Airworthiness Directive

AD No.: 2025-0205

ATR 42 and ATR 72 aeroplanes

ATA 53 – Fuselage – Passenger Seat Tracks – Inspection / Replacement

Appendix 2- Identification of 'UACE' seat tracks manufactured in or after 2024

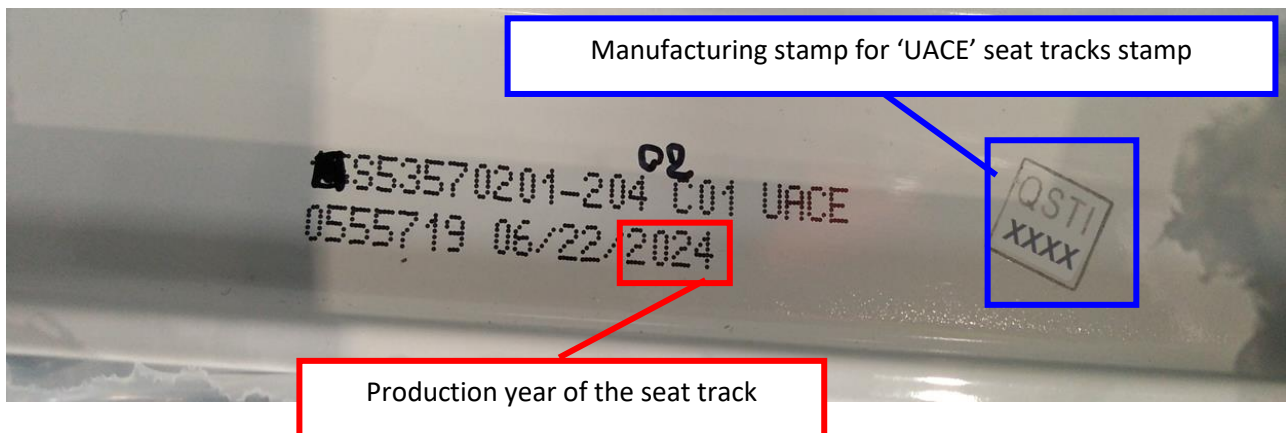
The identification of the seat track is located on the lower face of the seat track.

The manufacturing stamp of the seat track on the illustration corresponds to 'UACE' manufacturer, where 'XXXX' represents any numerical sequence.

The production year of the seat track on the illustration is 2024.

All the seat tracks having this manufacturing stamp and a production year equal to or above 2024, do not have to be considered as affected parts.

All the seat tracks with the manufacturing stamp and/or production year not visible/legible, have to be considered as potential affected parts.
